# Access Compliance Report

## Public Rights-of-Way

### (Curb Ramps)

| Intersection ID: 23917                  | Main Street: BOSHAM_LN | Cross Street: WHITWORTH_WY              | Location: NW           |

| ADA ID: AAC07818DE6B                    | Ramp Type: Perp        | Initial Pass/Fail: Fail                 | Overall Compliance: No |

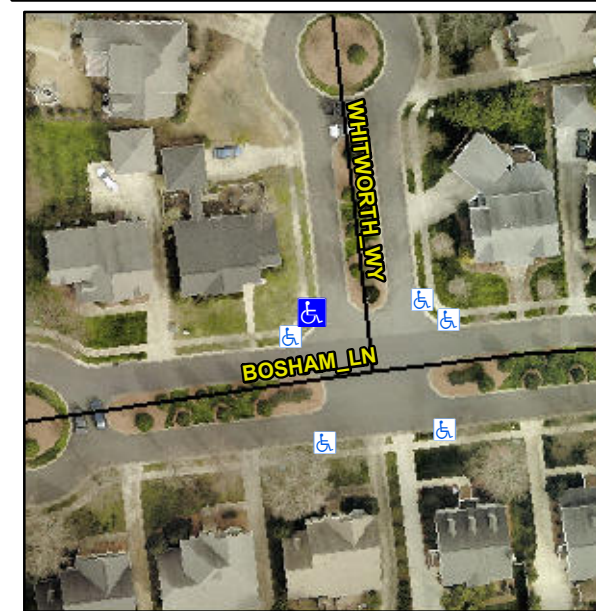
**Not Found, R304.5.1, R304.5.3**

| Compliance | Description           | Data | Compliance | Description                 | Data |
|------------|-----------------------|------|------------|-----------------------------|------|
| No         | Ramp Width (in)       | 37.0 | No         | Ramp XSlope (%)             | 2.6  |

**Remove & Replace Entire Ramp.**
